Technical Service Bulletin

20 MIL on or difficulty refueling, DTC P045100, P044100, P202500, and/or P045300 stored in the ECM

20 20 25 2050276/5 February 12, 2020. Supersedes Technical Service Bulletin Group 20 number 19-24 dated December 18, 2019 for reasons listed below.

Model(s)	Year	VIN Range	Vehicle-Specific Equipment
A6, A7	2016 - 2018	All	3.0T

Figure 1. How to determine which steps to take Version 1 (~4mm gap) or Version 2 (gap less than 2mm).

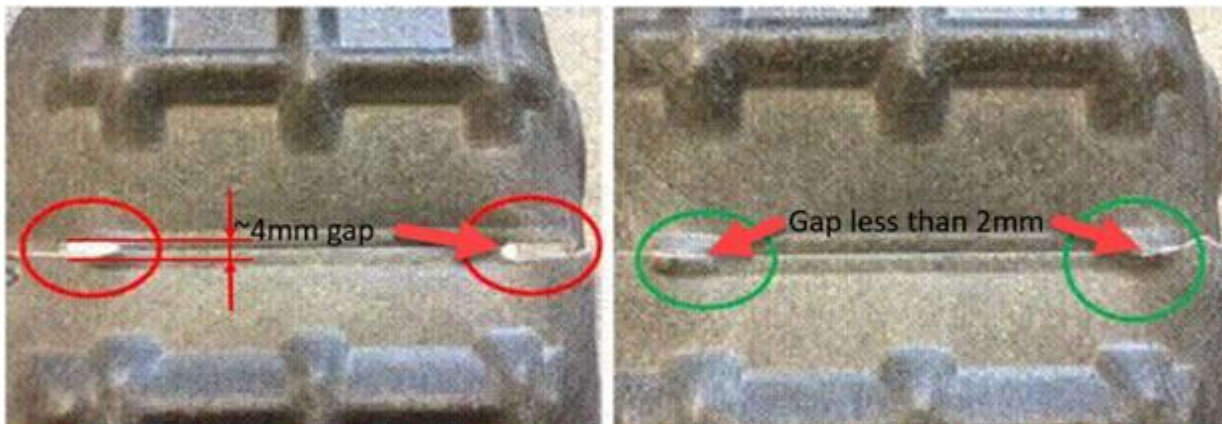
Version 1 (A6 only):

1. If the updated wheel liner has not yet been installed. Then install the updated wheel liner, which has closed slots around the NVLD filter.
 - Remove the EVAP canister, ventilation tube, and NVLD pressure switch.
 - Remove all components mounted on the EVAP canister.

Version 2:

If updated wheel liner has already been installed at previous repair or in the factory, the NVLD filter needs to be relocated into the engine compartment to prevent moisture entering the EVAP system, under extreme customer use conditions.

Figure 5. Route the 5/8" ID rubber hose from new filter position to the J909.

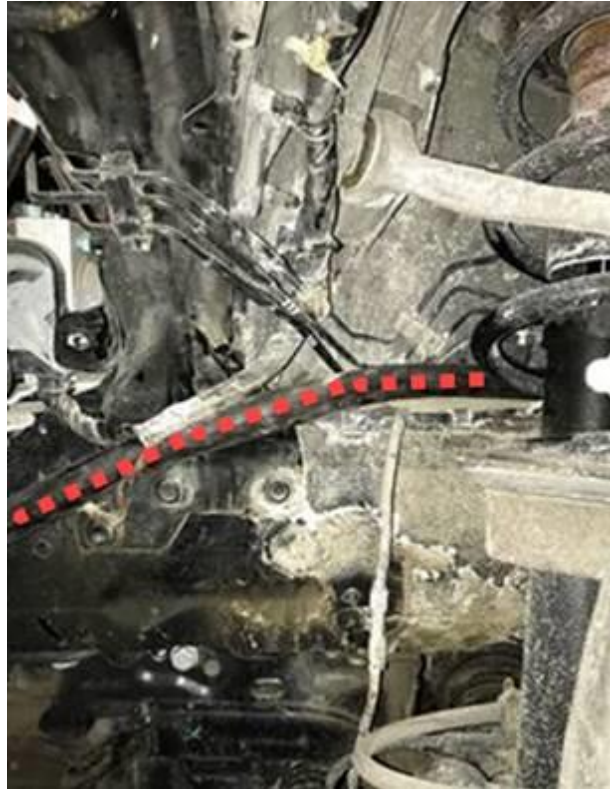
Route the 5/8" ID rubber hose behind the strut and brake lines from new filter position to the J909, along the orange battery cable (Figure 5 and 6). Then secure with zip ties.

5/8" ID rubber hose needs to be routed in a way that there are no sharp bends to prevent kinking.
